Antilles Regulatory Section
199905598(1P-ML)

Re: Strong Criteria for Final Approval of Permit Application
No. 199905598 (IP-ML), Joint Permit Application No.212.

**Technical Response to some of
the comments by the US Army
Corps of Engineers to permit
application number 199905598
(IP-ML)**

Figure 3. Discharge Curve for Downstream Cross Section

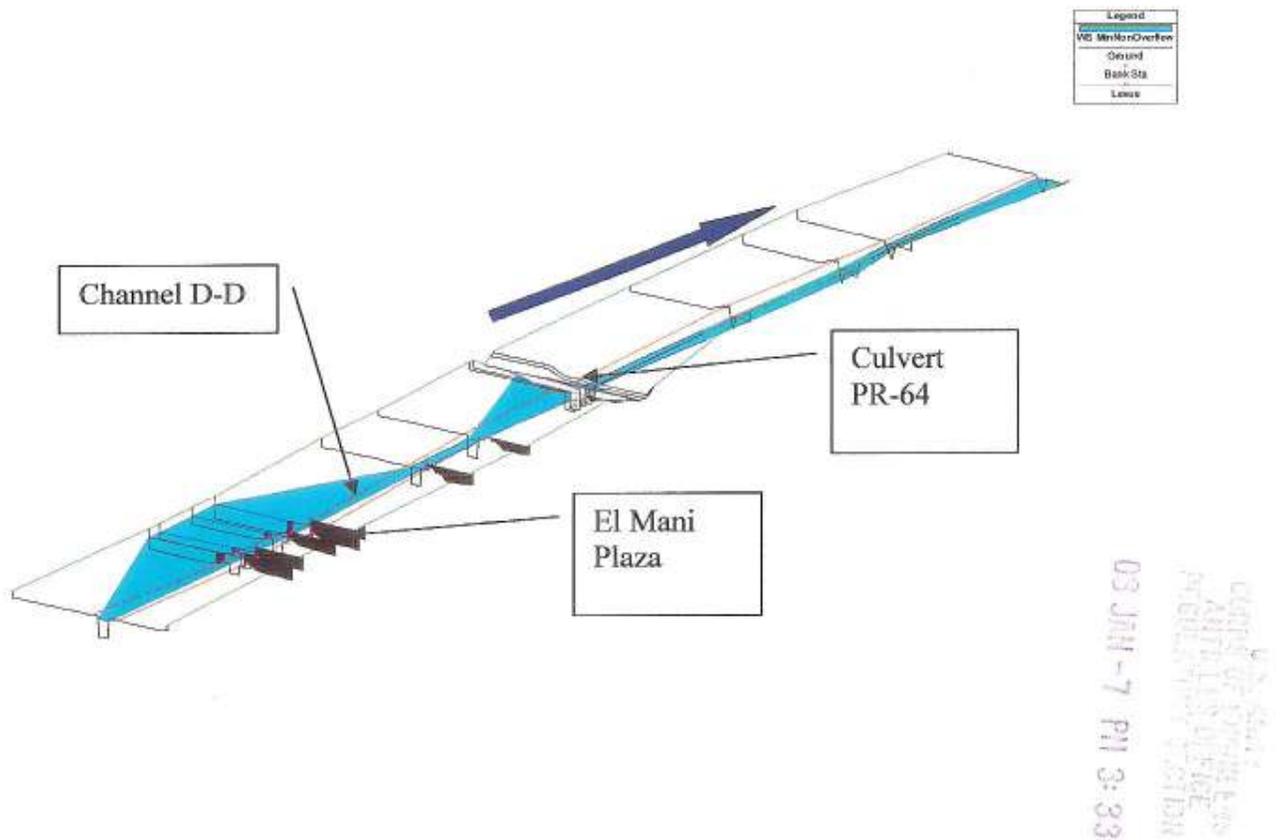
- 1) A discharge curve was obtained for the most downstream cross section. This section corresponds to Section 0 in the model titled "Canal Hacia el Norte". This model was called "Sistema Mani-Boquilla" in the H&H study (Appendix G), but, the new name is more accurate. The discharge curve is given in Figure 3.
- 2) Gradually varied flow computations were done in order to find the channel-forming discharge (the discharge that produces overflow) for channel D-D. The resultant flow is $7.5 \text{ m}^3/\text{s}$. The elevation at the downstream section corresponding to this discharge is 2.29 m. The model predicted overflowing at the culvert on PR#64. Figure 4 presents the results showing channel D-D overtopped for $7.5 \text{ m}^3/\text{s}$. The overflow elevation along channel D-D is 2.85 meters, as stated in

Figure 4. Schematic showing overtopping of Channel D-D, $Q=7.5 \text{ m}^3/\text{s}$

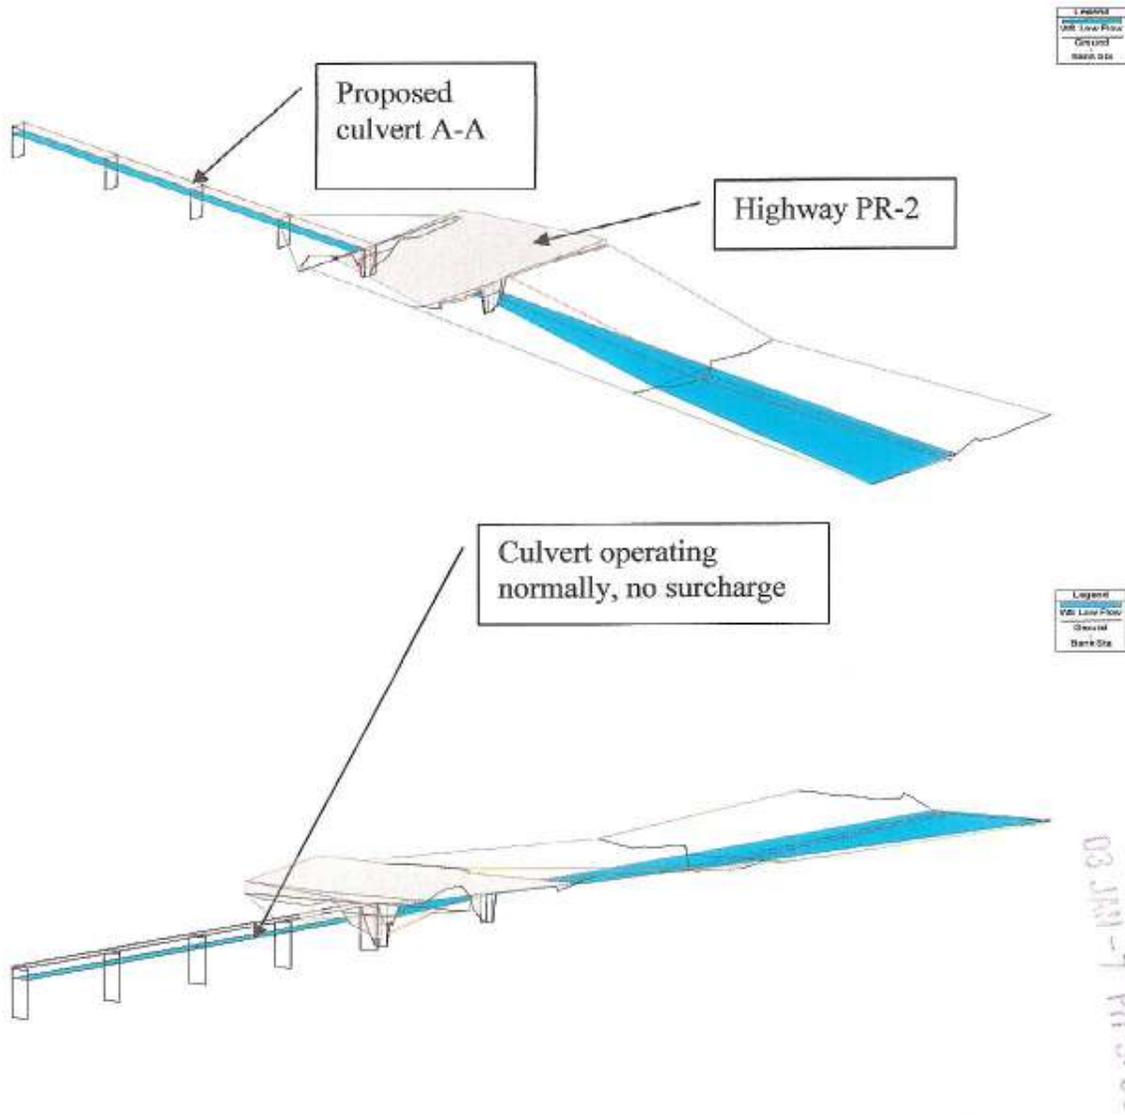
- 3) The water surface profile from step 2 predicted a water elevation at the beginning of channel D-D of 2.95 meters.
- 4) A flow of $0.54 \times 7.5 = 4.05 \text{ m}^3/\text{s}$ was used along the model for Boquilla Creek, called "Atarjea Quebrada Boquilla" in the H&H study (Appendix E). This model was improved by adding two more sections inside the property under study. The extended model was called "Atarjea Quebrada Boquilla Extendido" (Appendix 2 of this report). These computations allowed knowing if the property would be flooded by the new design before the new improved channel system will overflow.

The results, presented in Table 1, show that the water elevation at the culvert at PR#2 is 2.95 meters. This value is below the top chord elevation. The culvert is operating normally, and the upstream side will not be surcharged. The flow velocities are about 0.2 m/s. The channel will be overtopped upstream from the culvert site, inside the property under discussion (see Figure 5). The calculations demonstrate that the flooding conditions are not because of the culvert capacity or the Mani Plaza channels, but, because of the lack of maintenance of the Boquilla Creek to the east of PR#2. Figure 6 shows a recent picture of this channel (December, 2002). Vegetation has invaded the main channel; water finds a large resistance to flow. Presently, the same conditions are found on the El Mani Plaza side of the PR#2, as shown in Figure 7. The field inspection reveals that flow is stagnant due to the excessive vegetation and lack of infiltration capacity. The contrast with the cleaned and widened channel D-D, shown in Figure 1, is evident. All the pictures were taken the same day. The proposed conditions will solve this
